UNITED STATES PATENT AND TRADEMARK OFFICE

10/789,268

Office Action Summary	Application No. 10/789,268	Applicant(s) STAGER, BRADLEY R.	
	Examiner Bena Miller	Art Unit 3725

DETAILED ACTION

Figure 2 of Loth

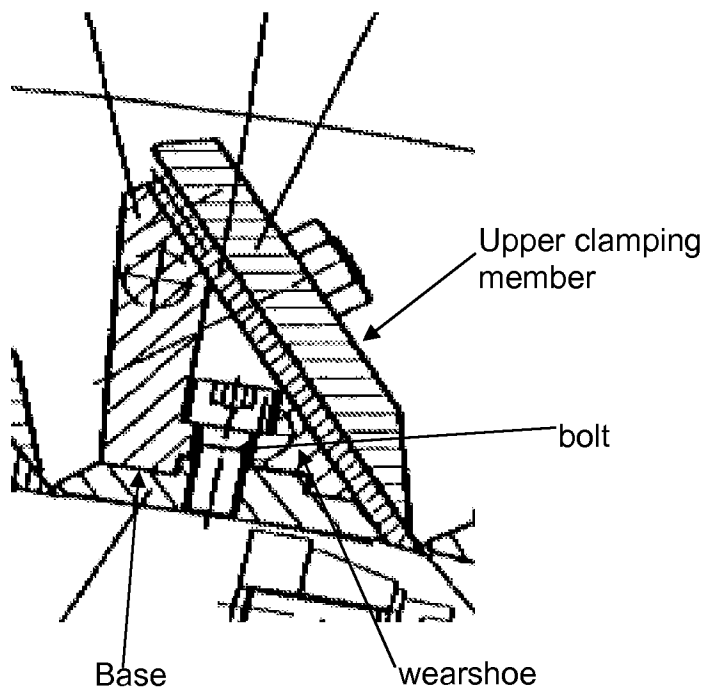
Claims 20 is rejected under 35 U.S.C. 102(e) as being anticipated by Loth.

The device of Loth teaches the elements of the claimed invention including a base, a wearshoe, at least one bolt and an upper clamping member as seen in the

marked copy Figure 2. It should be noted that the upper clamping member is engaged with the base via the wearshoe.
